Title: Schematics Design v1.0.SchDoc	
File: Salvatore Brake Kit v1.0.PrjPcb	
Date: 7/12/2023	Page Num: 1
Drawn By: Huzaifa Ali	Page Total: 1

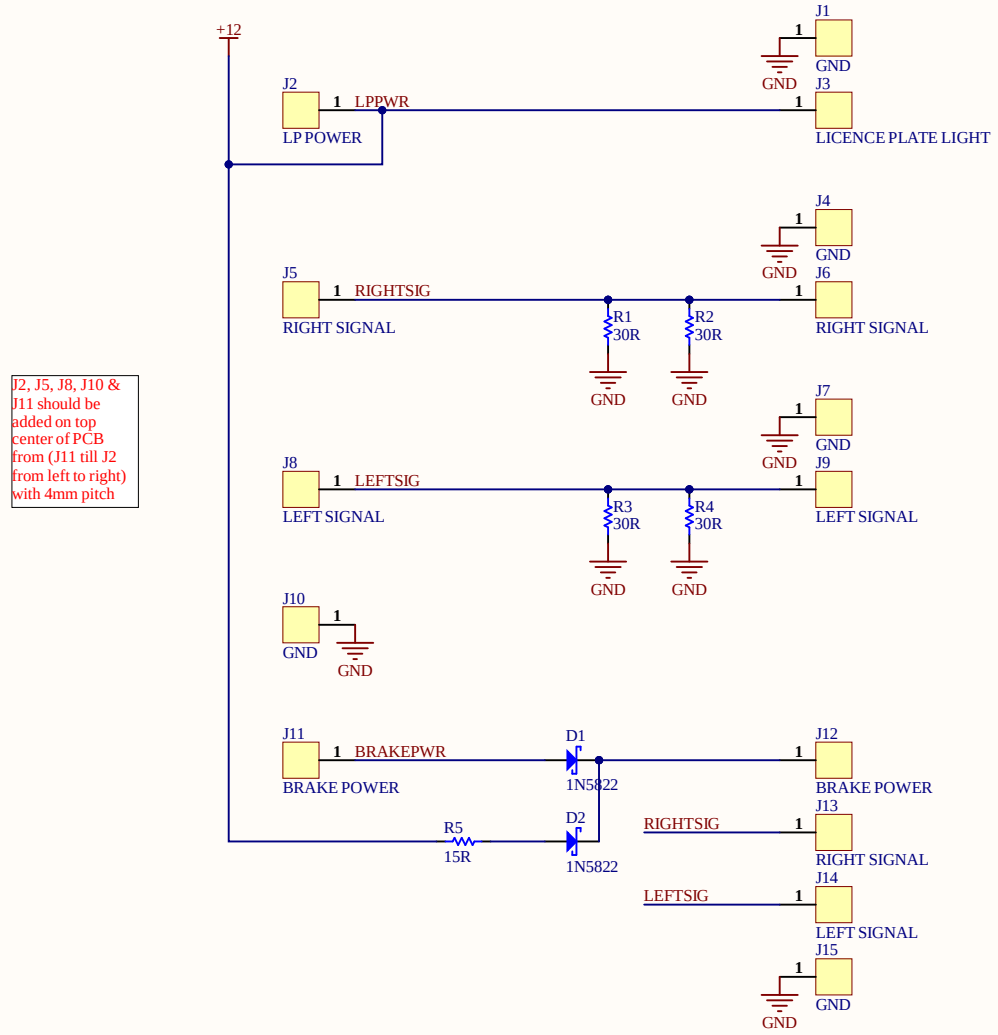
J2, J5, J8, J10 & J11 should be added on top center of PCB from (J11 till J2 from left to right) with 4mm pitch

J1, J3, J4, J6, J7 and J9 should be added on bottom right of PCB from (J9 till J1 from left to right) 4mm pitch

J12, J13, J14, J15 should be added on bottom left of PCB from (J15 till J12 from left to right) 4mm pitch

All the J designator should removed from PCB, instead label each pad with its name in PCB
